Seismic Walkdown Checklist (SWC)Equipment ID No. 2H21-P021 Equip. Class¹ 18Equipment Description RHR Instrument RackLocation: Bldg. REACTOR Floor El. 87 Room, Area SE Diagonal Unit 2

Equipment ID No. 2H21-P021 Equip. Class¹ 18

Equipment Description RHR Instrument Rack

Figure 3 – Missing Anchor on Rack Support (2H21-P021)

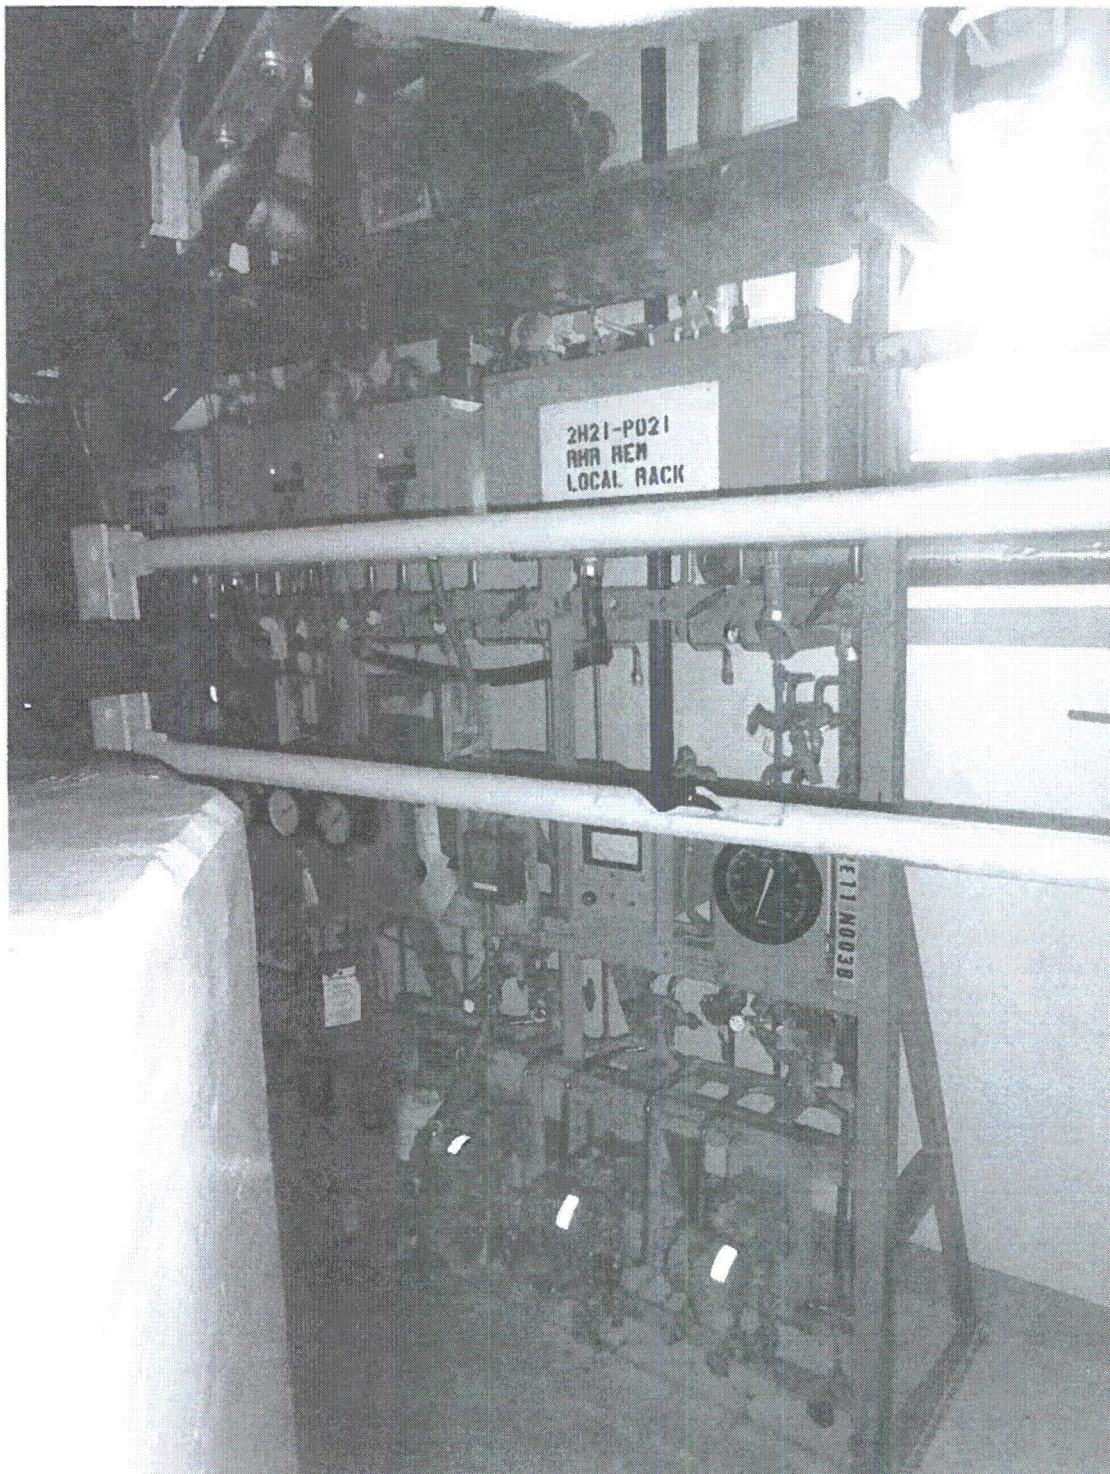
2. Is the anchorage free of bent, broken, missing or loose hardware? Y N U N/A
There is one anchor missing on the south side of the support for Instrument Rack 2H21-P021 (CR 515727). There is a good deal of debris in the hole, so it is unsure whether the anchor is broken off, removed or was never installed. There are seven other anchors in good condition, and the rack frame is very stiff.

Figure 3 View of Anchors with Cut Washers

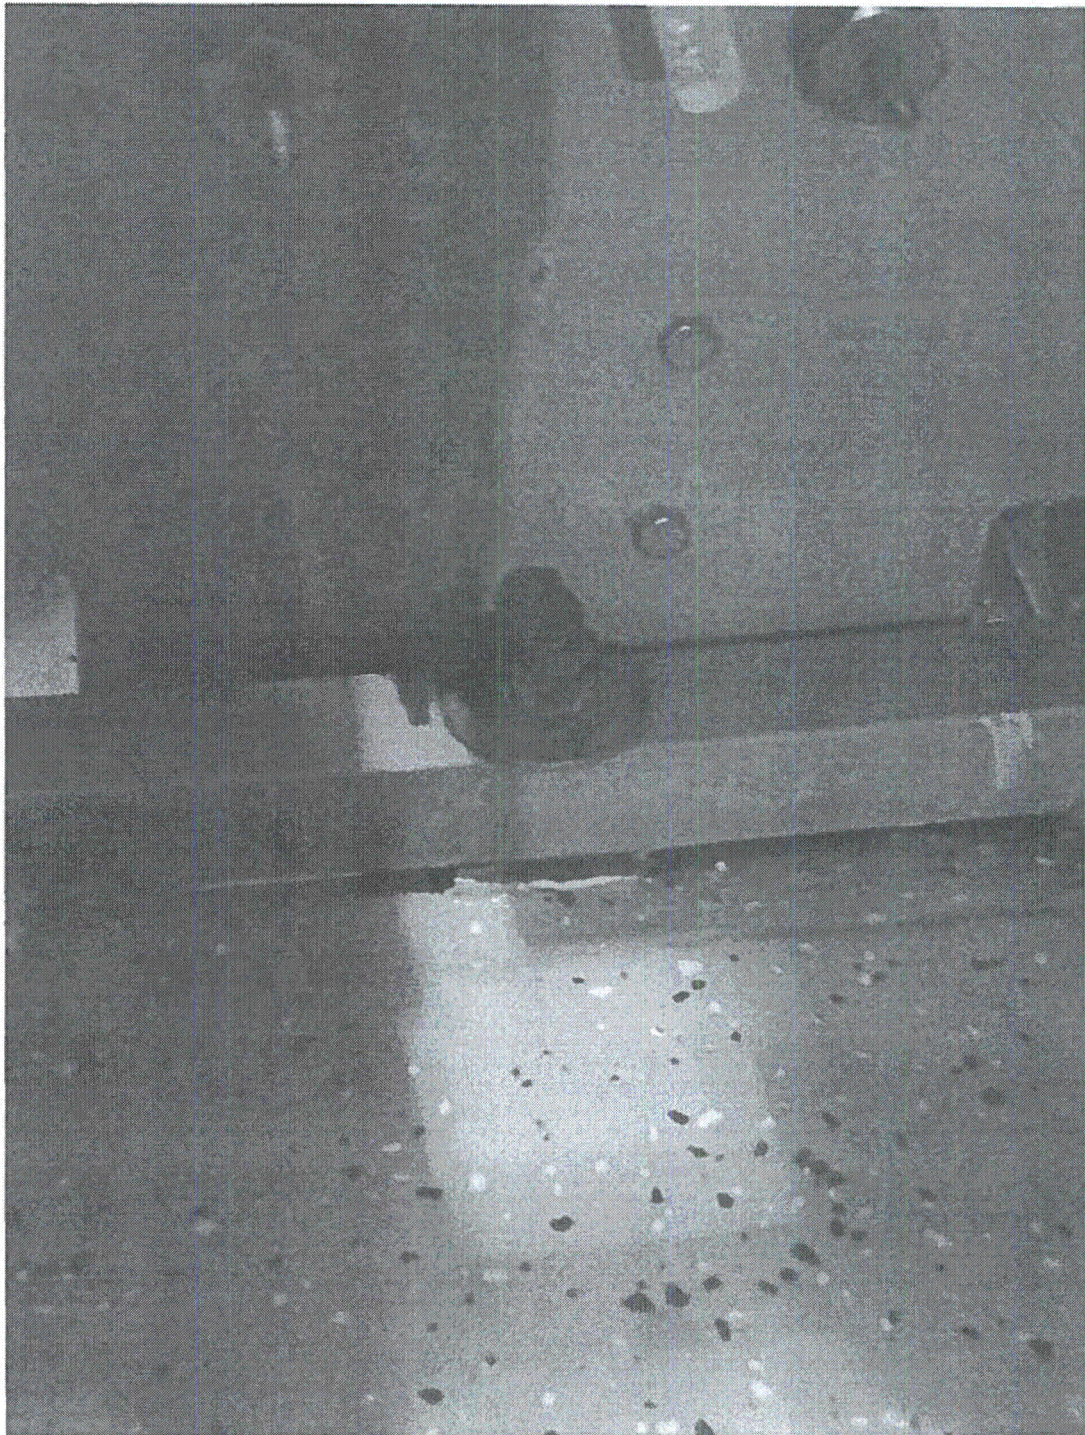
2. Is the anchorage free of bent, broken, missing or loose hardware? Y N U N/A
There are four anchors of the 10 anchors that have cut washers. The cutting of these washers has no affect on the ability of these four anchors to carry the seismic loads applied to them during a seismic event. Therefore, the anchorage is seismically acceptable.

Figure 3 – Gap Between Conduit and Component (2T48-N009A)

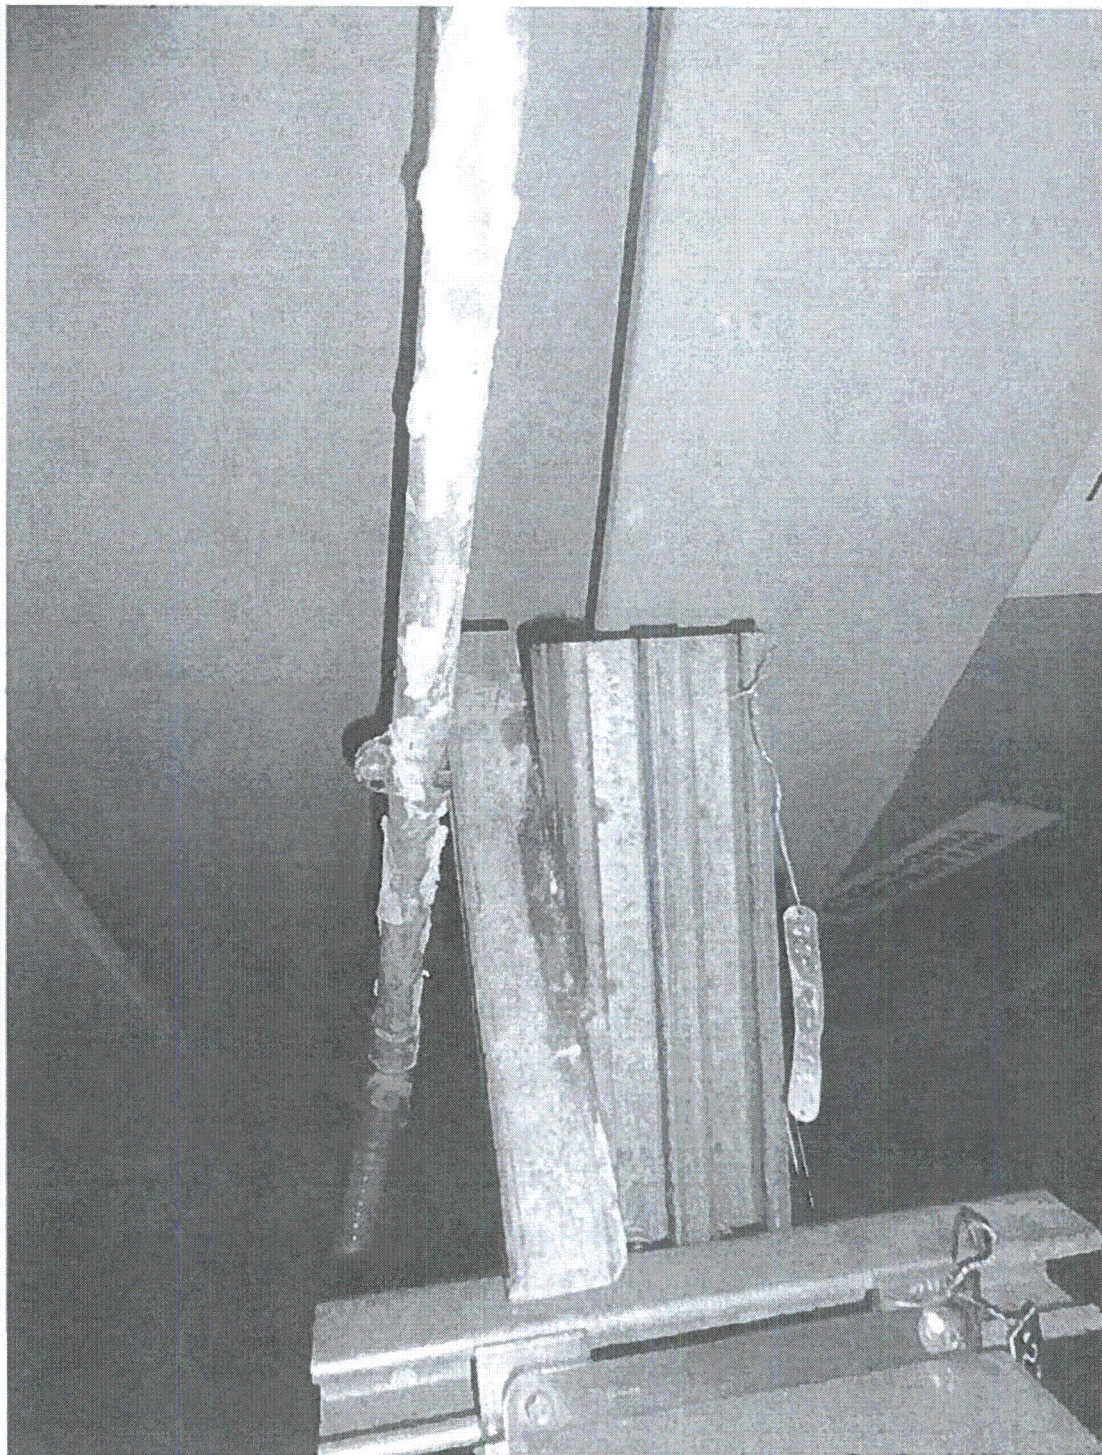
- 7. Are soft targets free from impact by nearby equipment or structures? Y N U N/A
There is a conduit running past the component to the wall that passes approximately 1" from the equipment. The conduit is attached to the same support as the temperature element, so the two components will move together. Since there will be no differential seismic motion between them, there is no potentially adverse seismic condition.
- 8. Are overhead equipment, distribution systems, ceiling tiles and lighting, and masonry block walls not likely to collapse onto the equipment? Y N U N/A

Figure 3 – Bolt Lacking Full Thread Engagement (2T41-N020A)

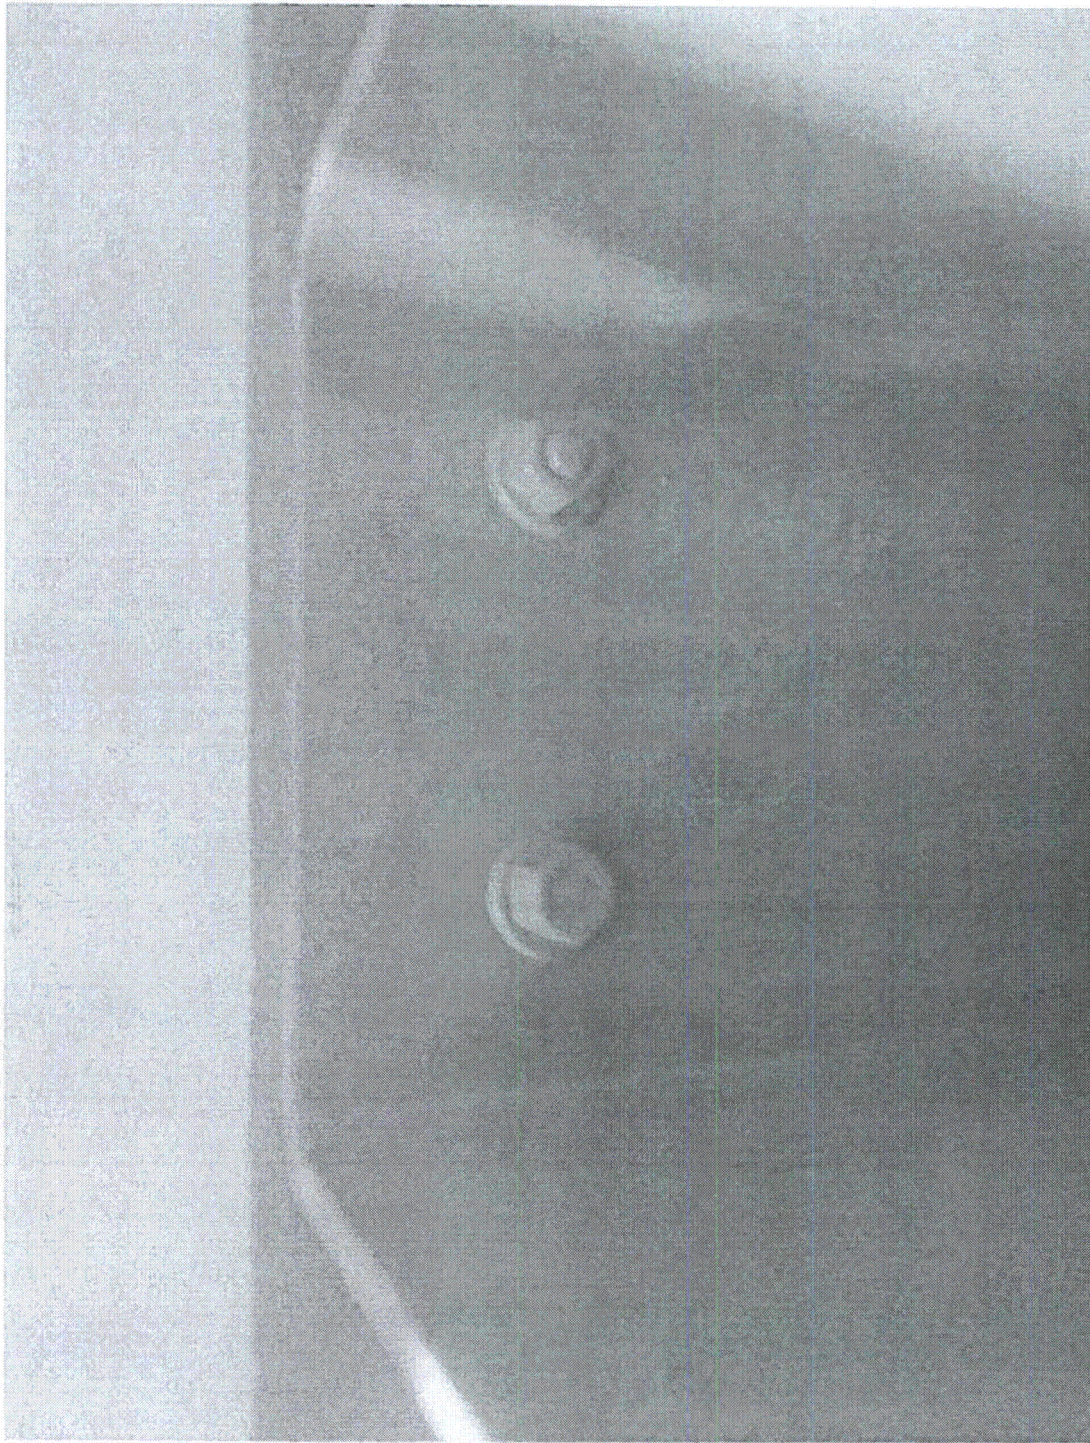
6. Based on the above anchorage evaluations, is the anchorage free of potentially adverse seismic conditions? Y N U
The top left anchor does not have full engagement of the bolt. The end of the bolt is approximately 1/16" below the nut. The other three bolts are fully engaged 3/8" dia. anchors, and have enough capacity to support the small, light component. Therefore, there is no potentially adverse seismic condition.

Figure 2 Component Anchorage to Wall

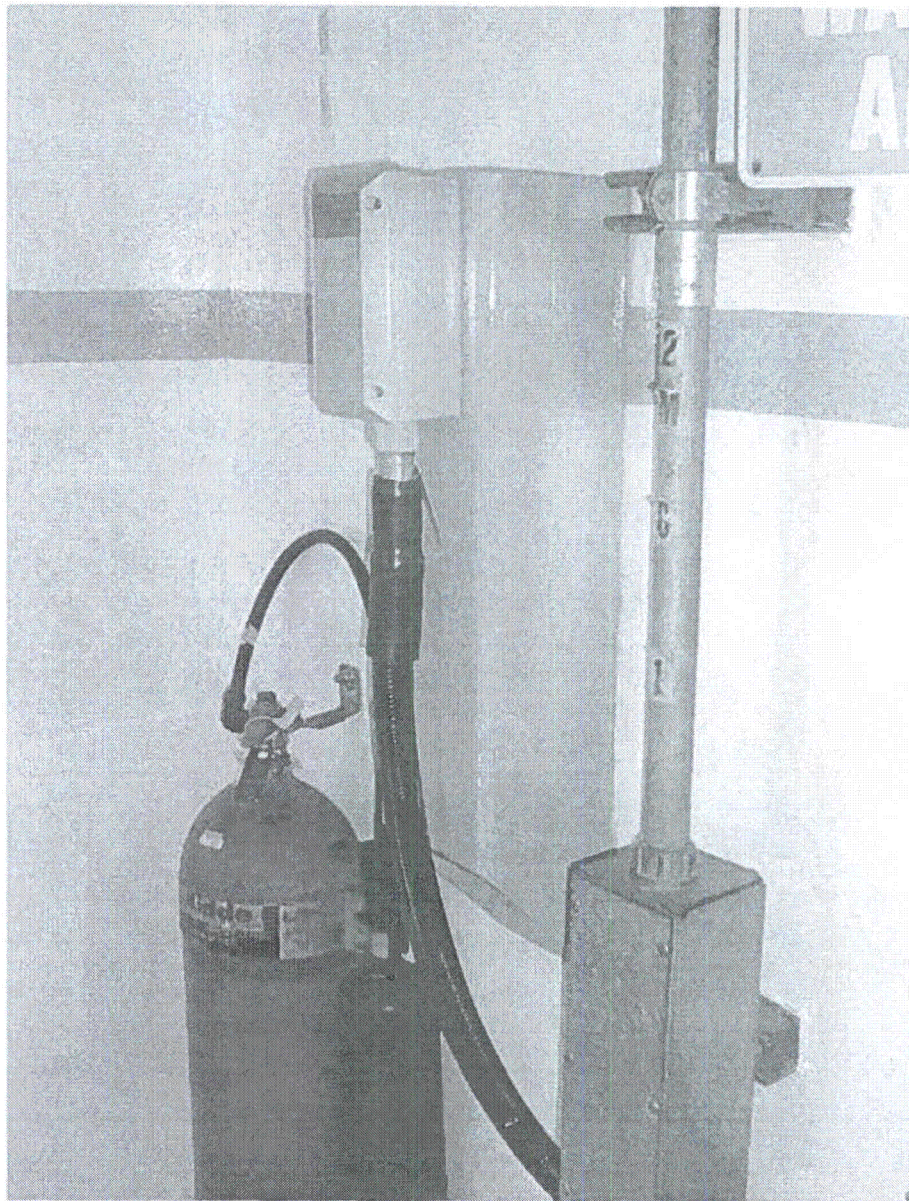
Component tag is barely visible. The tag is a small embossed tag. The companion junction box has a tag number written on it but the ink is fading.

3: Missing Plug Welds (2R43-P001C)

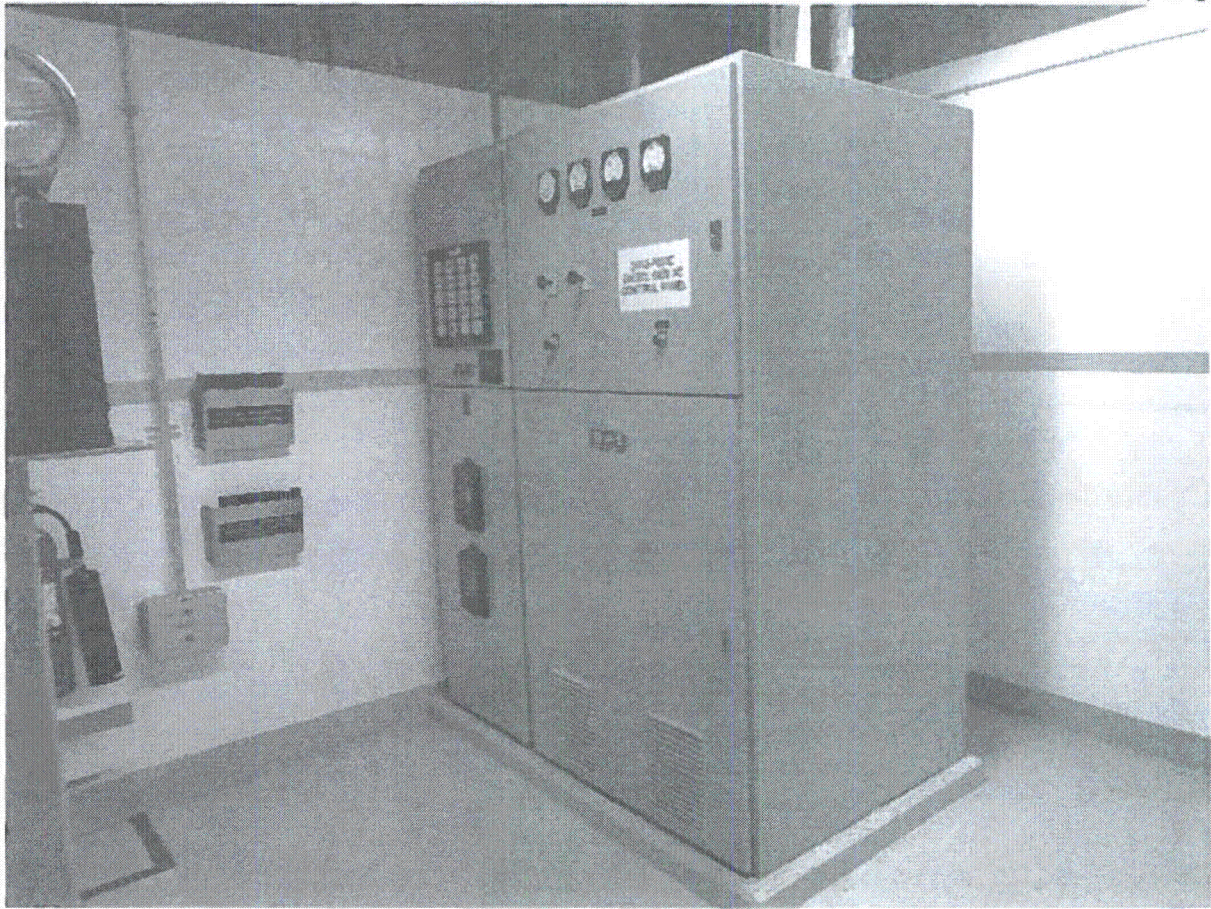
5. Is the anchorage configuration consistent with plant documentation? Y N U N/A
 (Note: This question only applies if the item is one of the 50% for which an anchorage configuration verification is required.)
Anchorage verified using calculation SCNH-99-406, Rev. 0. A SEWS package dated 10/25/1988 is included within the body of the calculation. There are fillet welds present inside the west side of the panel, northwest section. There are plug welds at the holes of the angle base of the panel. Two holes are not plug welded, which are located at the northwest section (south end of that section) and the southwest section (north end of that section). See photograph 3.

Calculation SNCH-99-406, Rev. 0 provides the SQUG evaluation for this control panel. The SQUG evaluation only takes credit for welds on the outside of the panel. The interior fillet and plug welds are not considered as part of the anchorage in the calculation. The addition of the plug welds and interior welds only increases the capacity of the panel anchorage. Therefore, it is consistent with the plant documentation.

3: Loose Cables Inside Cabinet (2C82-P001)

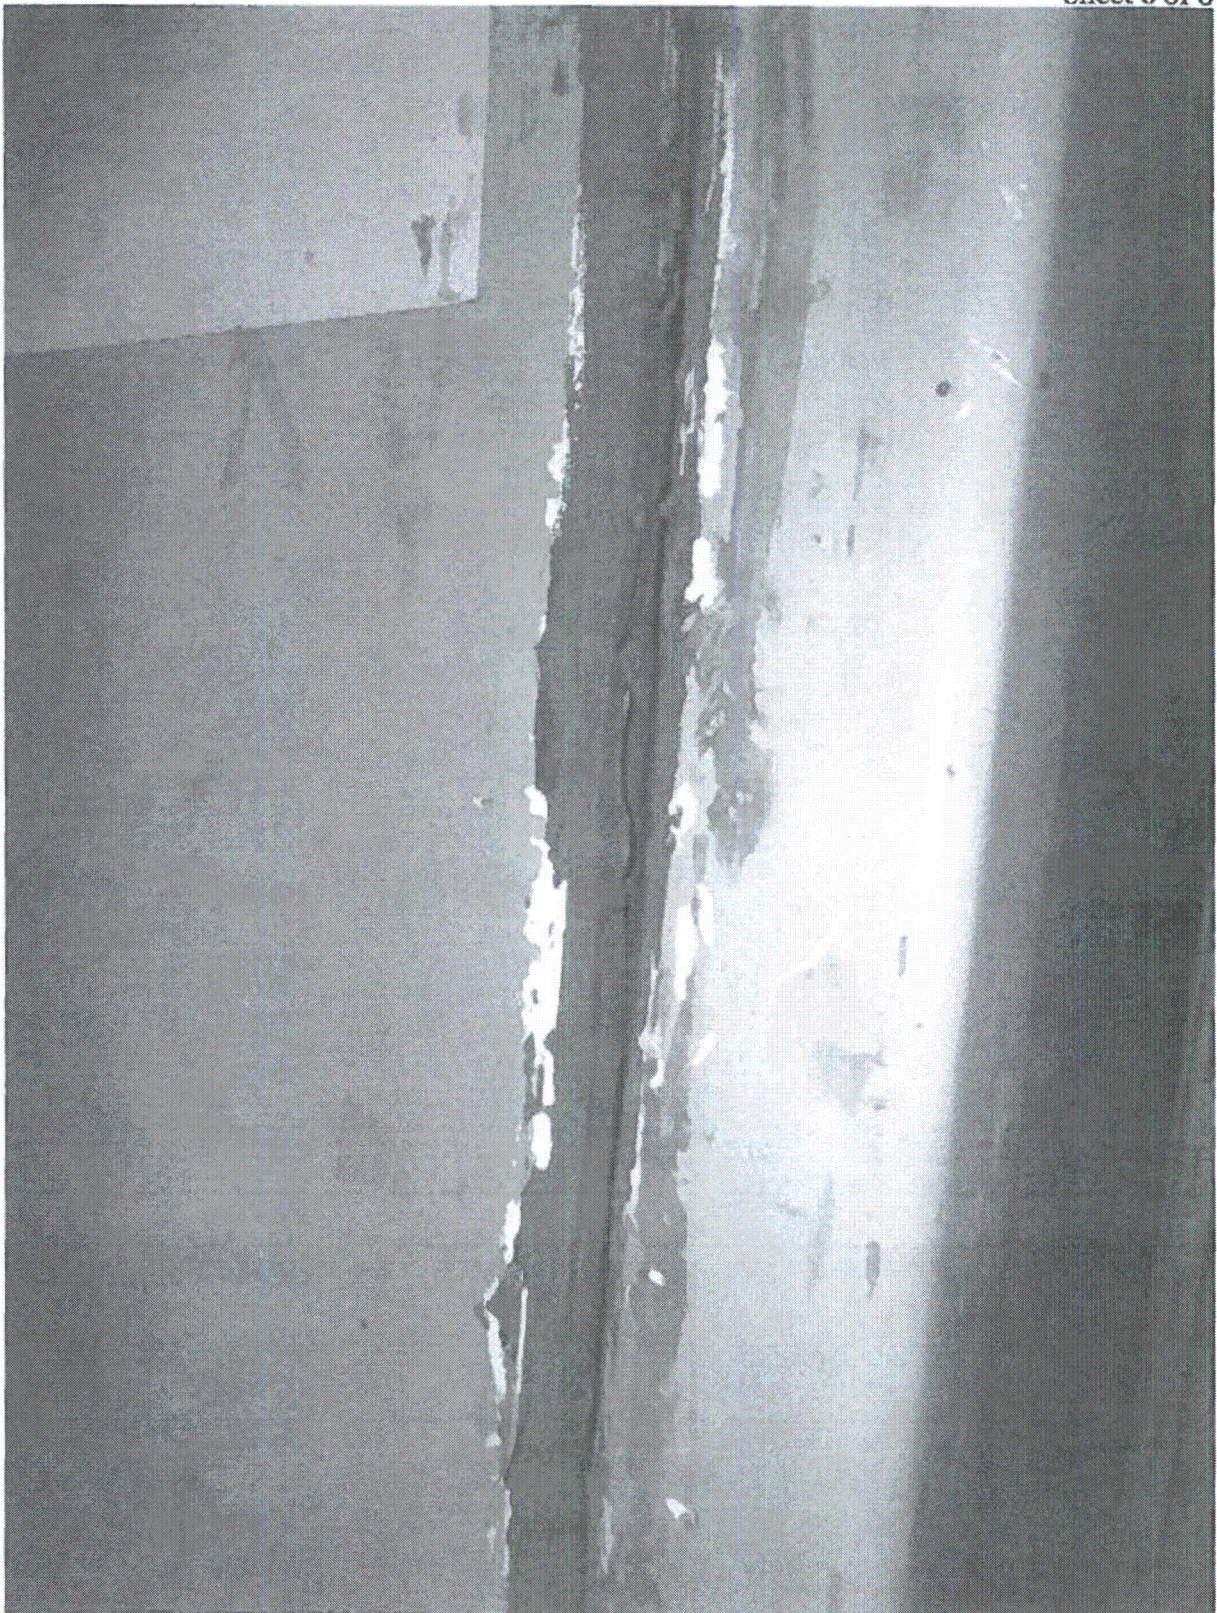
- 11. Have you looked for and found no other seismic conditions that could adversely affect the safety functions of the equipment? Y N U
There are several cables not properly secured inside the panel (see photograph 3). Movement of the cables will not adversely affect the seismic capacity of the panel anchorage and the cables are not located near any safety-related components that could be damaged by impact from the cables. It is judged to be seismically adequate.
Components inside panel were inspected visually in accordance with the direction provided in the FAQ related to opening panels.
